## **REMARKS**

This is an Amendment and Reply to the Office Action dated February 13, 2004. Claims 1-9 are pending in this application. By this Amendment, claims 1-9 have been cancelled and claims 10-23 have been added. Accordingly, claims 10-23 are now at issue.

Fig. 2

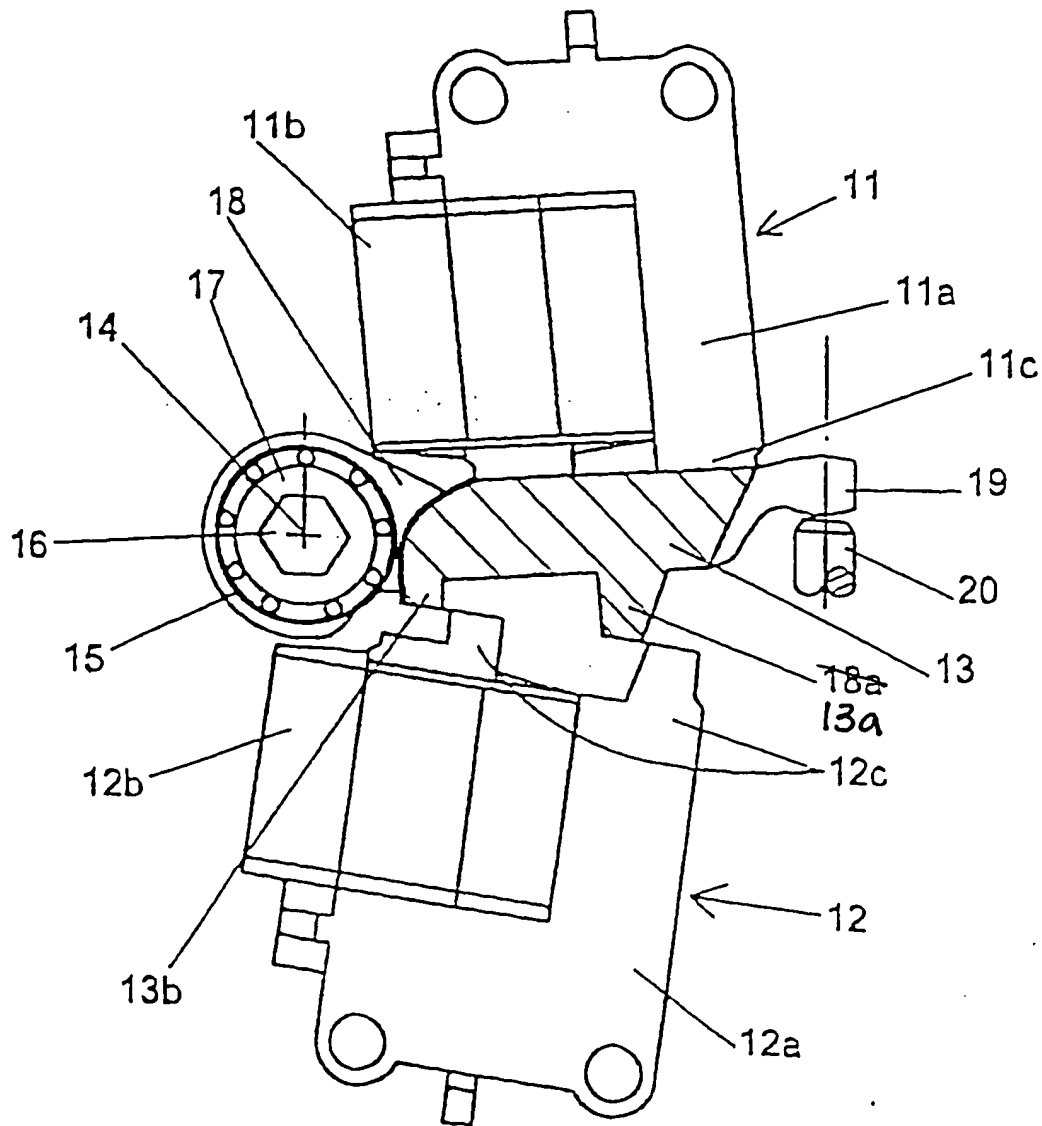
The Examiner has objected to FIG. 2 of the drawings for failing to identify element number 13a and also including element number 18a, which is not discussed in the specification. The Applicant submits that the element that element number "18a" refers to was inadvertently mislabeled. This element should have been labeled as "13a." Accordingly, the drawings have been amended to correct this error. The Applicants respectfully request approval of the amended drawings.
